From: [Charles Palmer](#)
To: Jemberie_Shiferaw@DOT
Cc: [OPR State Clearinghouse](#); gkathan@co.calaveras.us; MFlandreau@co.calaveras.ca.us; Ponce_Gregoria@DOT; [Joe DiGiorgio](#); [Julia Richardson](#)
Subject: RE: Caltrans comment letter - West Point and Wilseyville Wastewater Treatment project
Date: Tuesday, January 18, 2022 8:31:57 AM
Attachments: [Drainage Mods CCWD-WestPoint WWTF.pdf](#)

FACULTATIVE SLUDGE LAGOONS DRAINAGE, PAVING AND GRADING PLAN
 WEST POINT – WILSEYVILLE
 WWTF CONSOLIDATION PROJECT

15091
PROJECT NUMBER
C801
DRAWING NUMBER
28
SHEET NUMBER

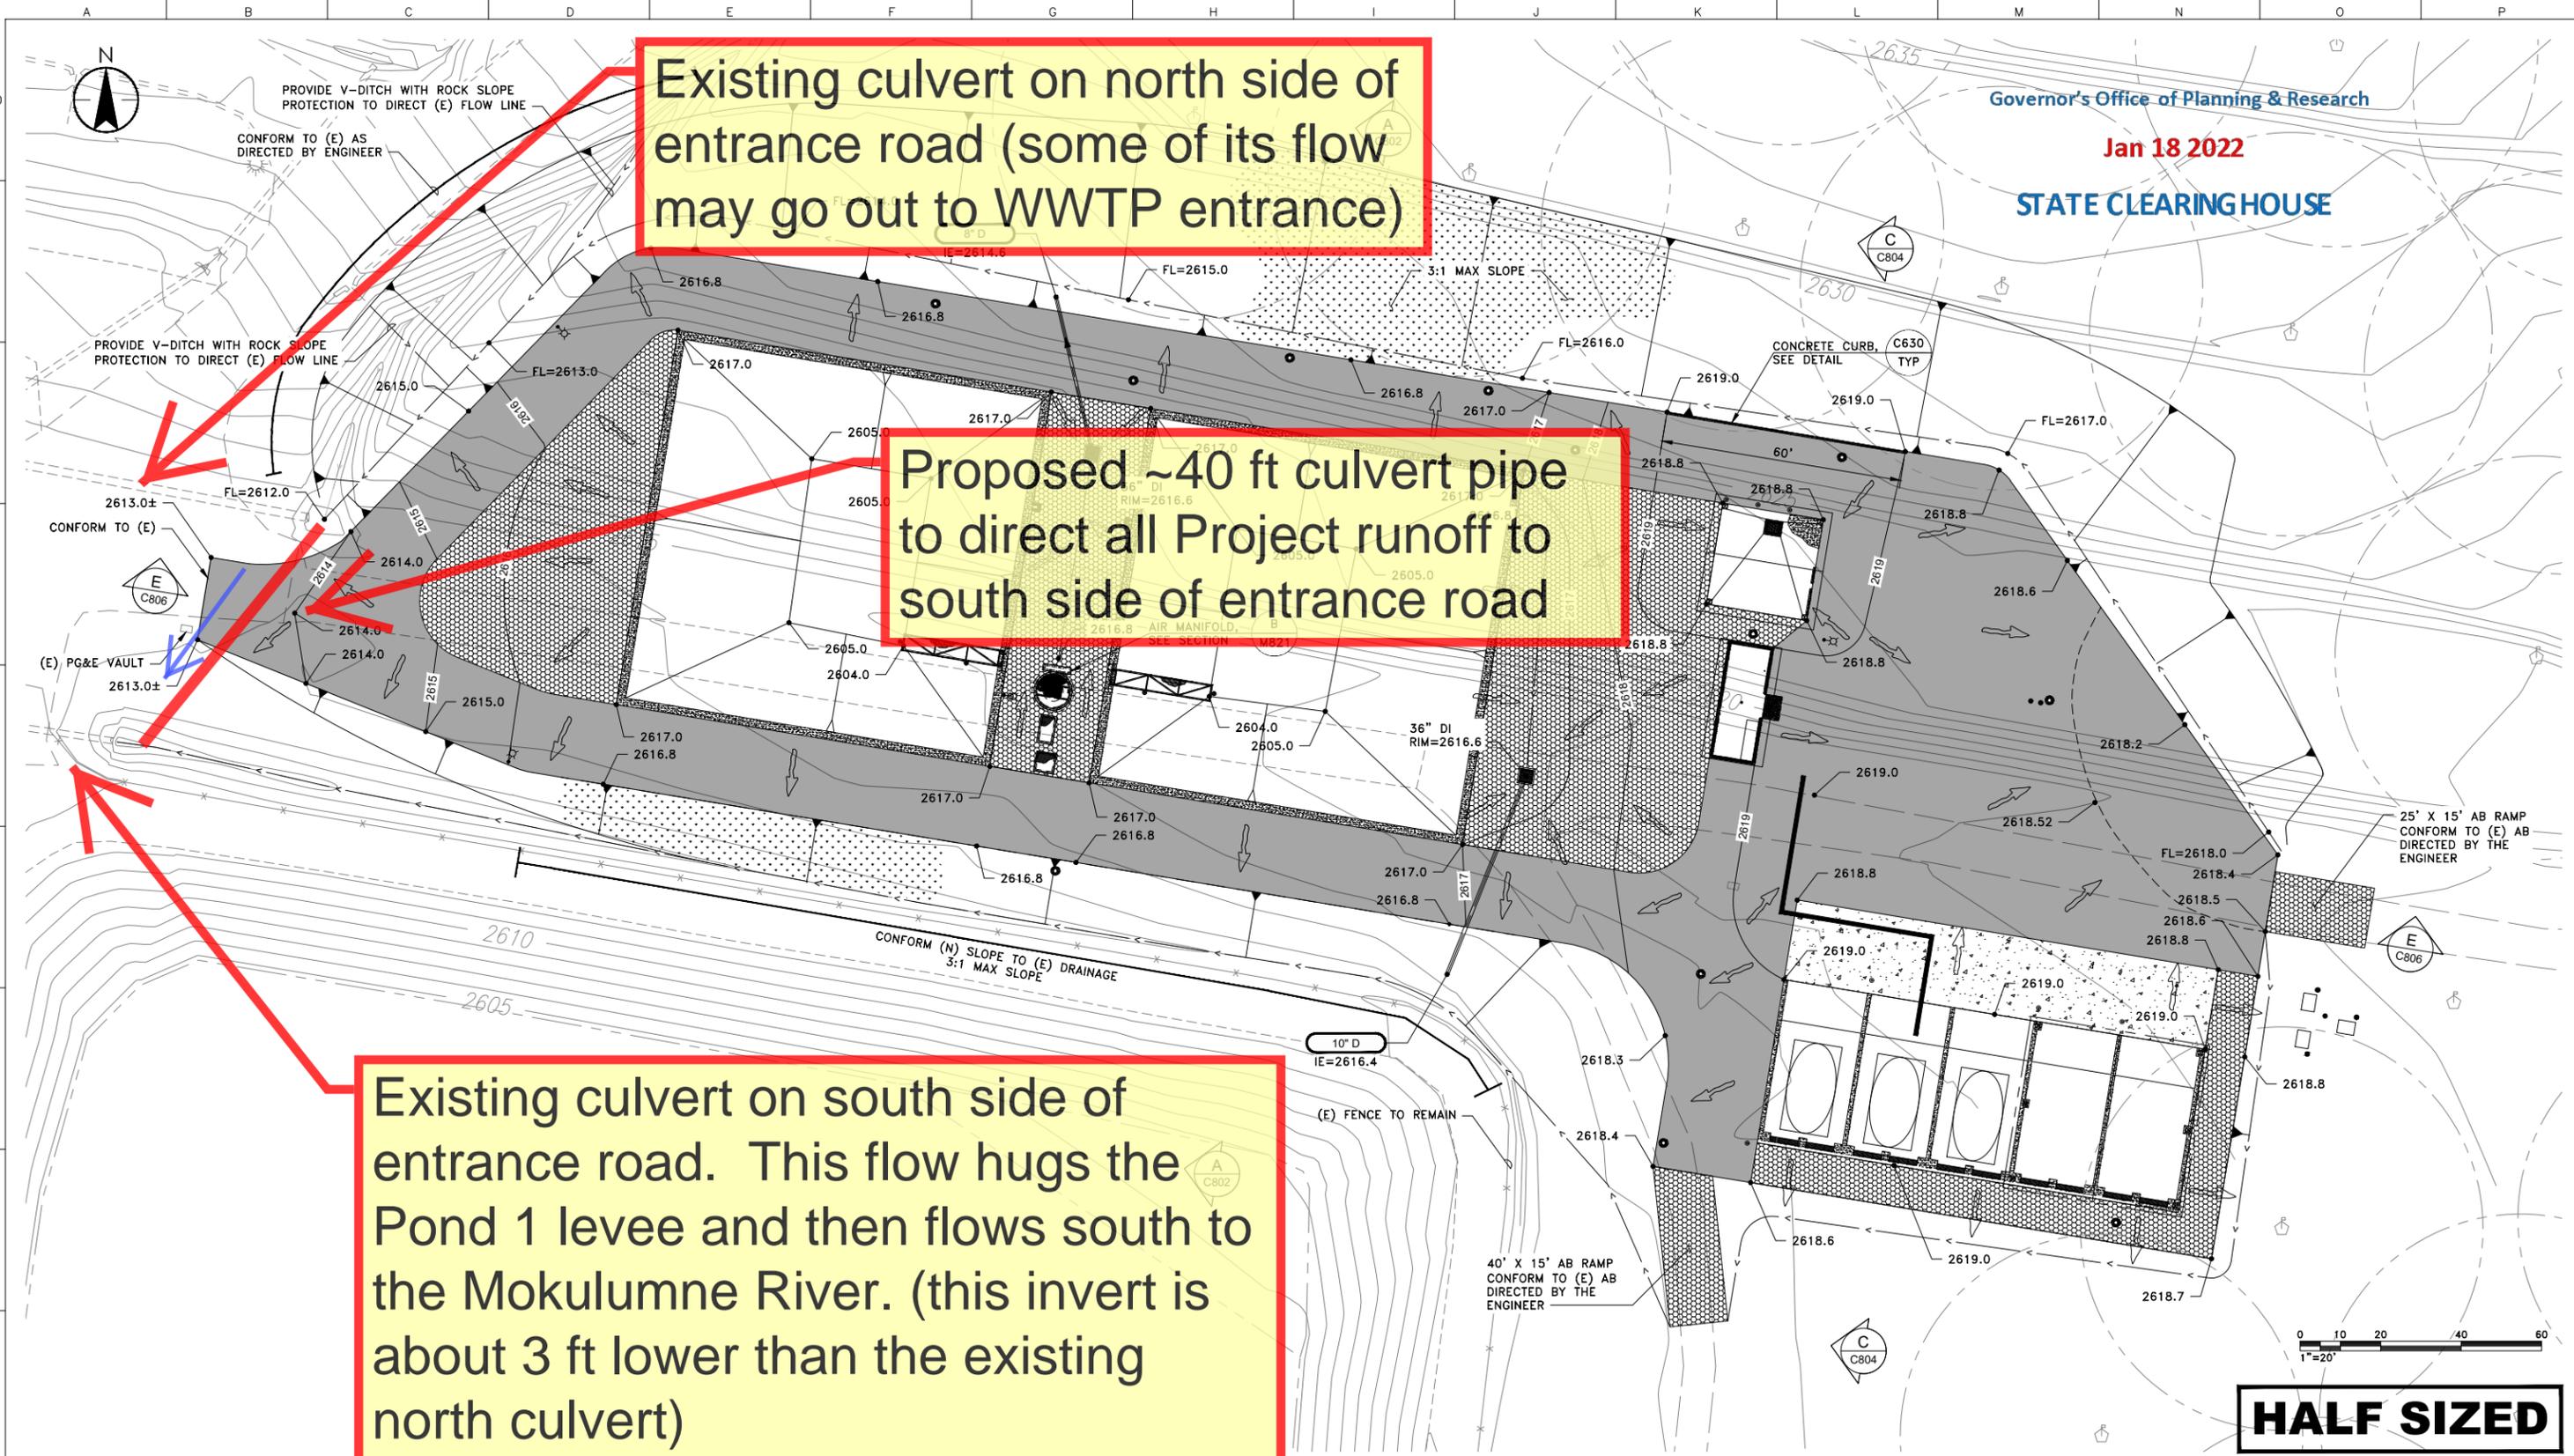
Our design consultant, Nexgen, has evaluated the potential runoff from our project site and determined that a very small amount of the project site does slope toward the property entrance and runoff could potentially reach the highway (State Route 26) right of way and add a small amount of new, additional runoff to pre-existing drainage facilities. Further analysis by Nexgen showed that this runoff could be diverted away from the State's right-of-way and reduced below pre-existing levels by the addition of a small on-site culvert 12" to 16" diameter x 40' long to our project. We intend to include the subject culvert in our project as a result of your comments. Please let us know if you would like to further discuss our project and the information presented herein and we can schedule an online MS Teams meeting with Calaveras County Water District and our consultant, Nexgen.

Existing culvert on north side of entrance road (some of its flow may go out to WWTP entrance)

Proposed ~40 ft culvert pipe to direct all Project runoff to south side of entrance road

Existing culvert on south side of entrance road. This flow hugs the Pond 1 levee and then flows south to the Mokulumne River. (this invert is about 3 ft lower than the existing north culvert)
